REVIEW NOTES
GUILFORD BRO 1442(36) – BRIDGE NO. 65
TRAFFIC CONTROL PLAN
June 30, 2014

RE: Temporary Traffic Control Plan received from Renaud Bros. Inc on 6/26/2014.

This submittal review is for sheet 1, inclusive, of the “Guilford (36)-TrafficControlPlan” submittal received on 6/26/2014.

TRAFFIC CONTROL PLAN - ROAD CLOSED TO TRAFFIC NOT TO SCALE

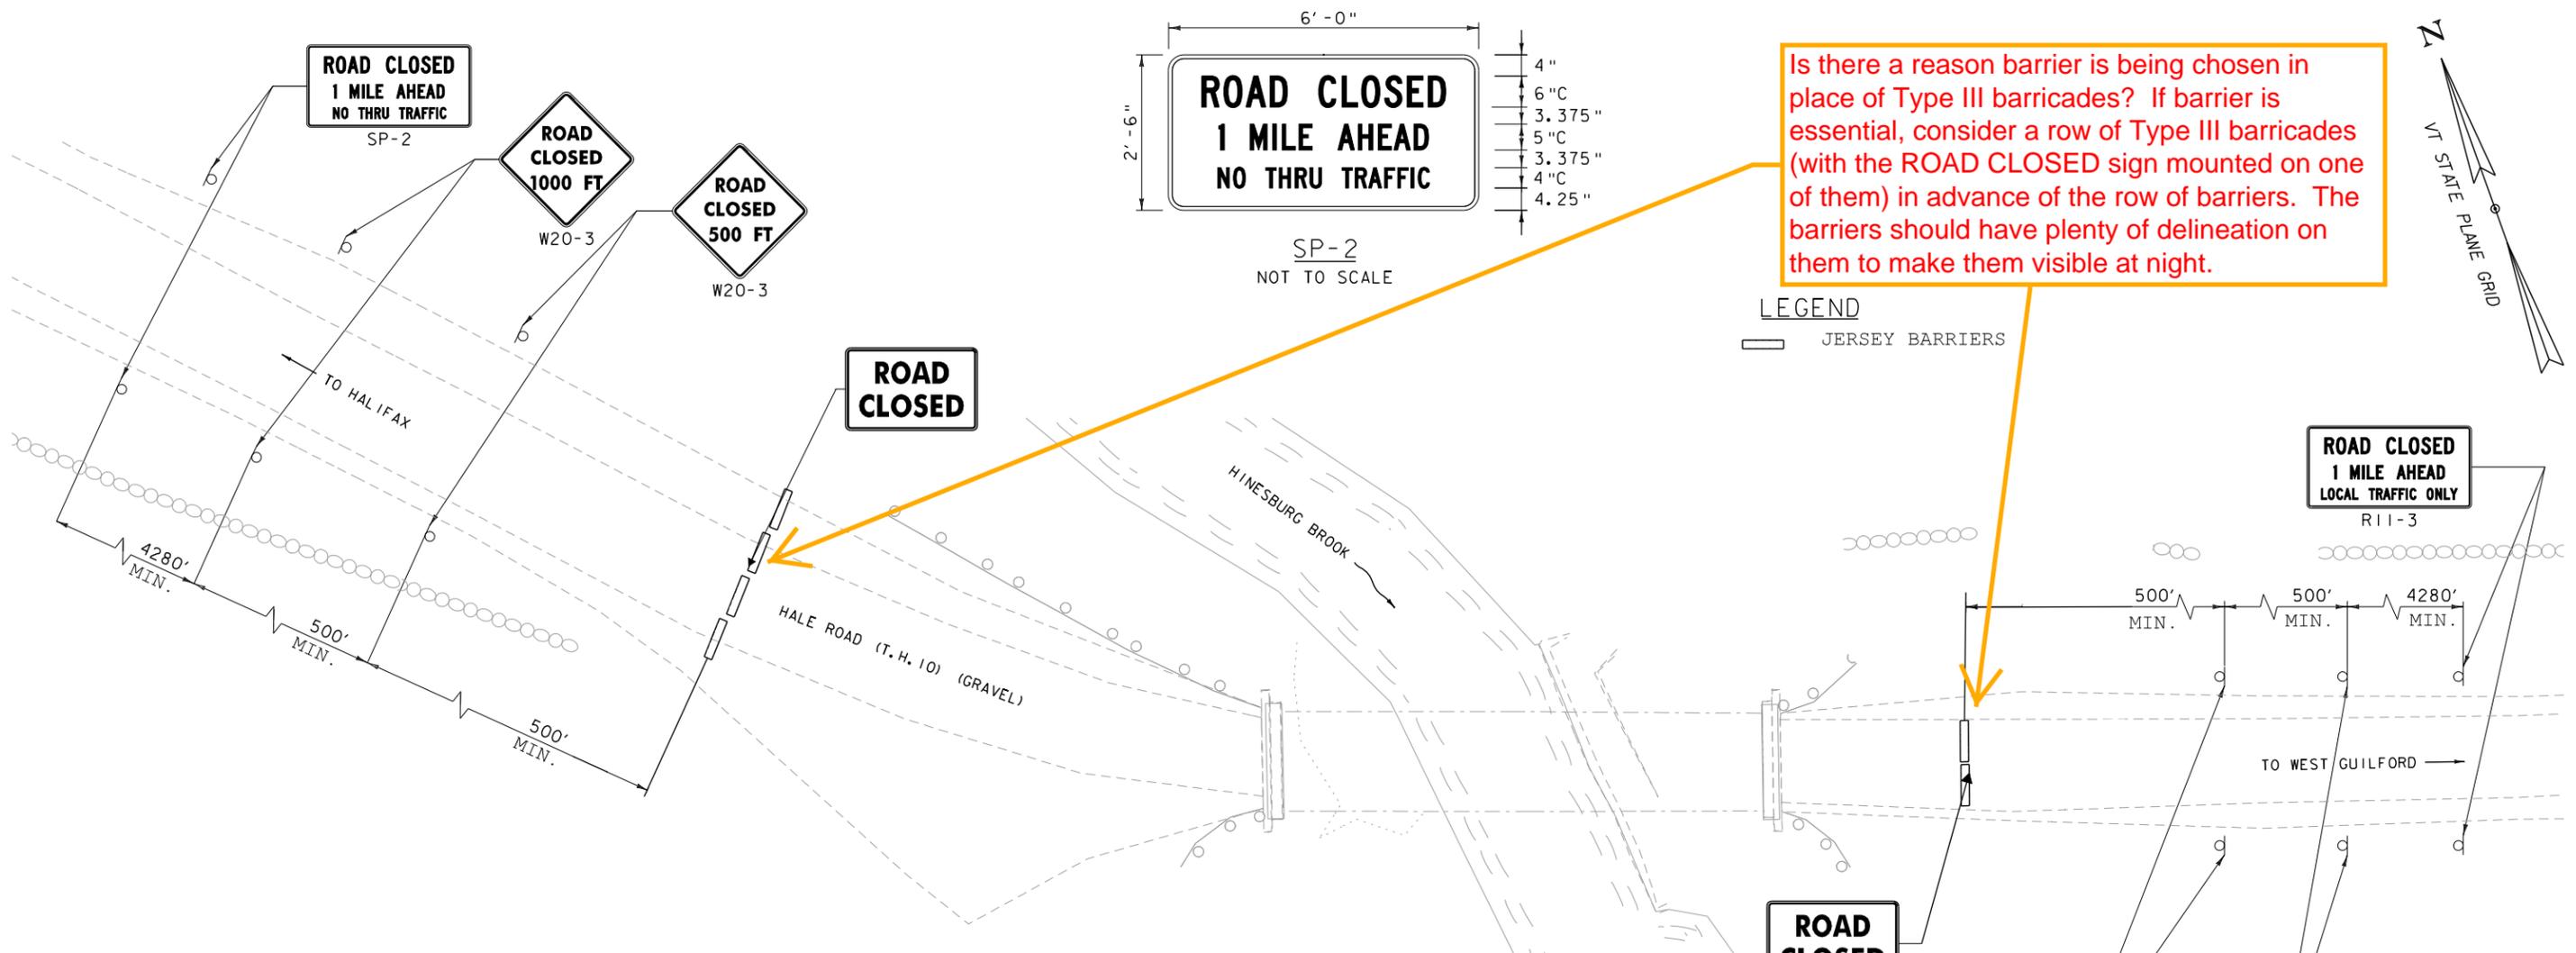
Is there a reason barrier is being chosen in place of Type III barricades? If barrier is essential, consider a row of Type III barricades (with the ROAD CLOSED sign mounted on one of them) in advance of the row of barriers. The barriers should have plenty of delineation on them to make them visible at night.

Don't need to spec FW, there is no such thing as fluorescent white. (Type IX white exists, but it's not fluorescent). B/W is fine to specify here.
